May 18, 2023

Town of Chapel Hill
Planning Department
405 Martin Luther King Blvd.
Chapel Hill, NC 27514

Please see below our responses and proposals for the major items discussed at our April 19, 2023 council hearing.

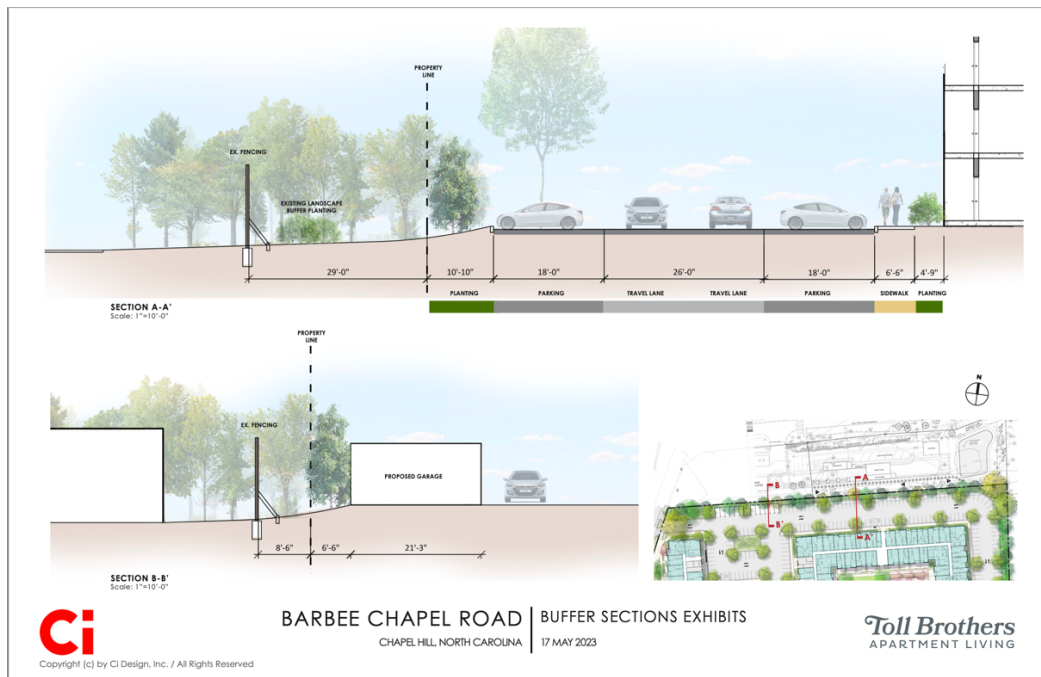
Parking: Too much, too visually dominant

- Original Proposal:
 - o 495 TOTAL (1.4 spaces per unit)
 - 455 surface
 - 16 garages
 - 24 TH garages
- New Proposal: 49 FEWER parking spaces
 - o 446 TOTAL (1.3 spaces per unit)
 - 406 surface
 - 16 garages
 - 24 TH garages
 - o Better design to reduce visual dominance of parking
 - More tree islands along "main street" to replicate rhythm of street trees
 - Larger tree islands to allow for larger tree species

- This combination will increase shade, reduce the potential for a heat island effect, and reinforce the “outdoor room” being created along this east-west corridor
- Compare to Nearby Apartment Properties
 - Bell Meadowmont: ~1.8 Parking spaces per unit
 - The Morgan: ~1.8 Parking per unit
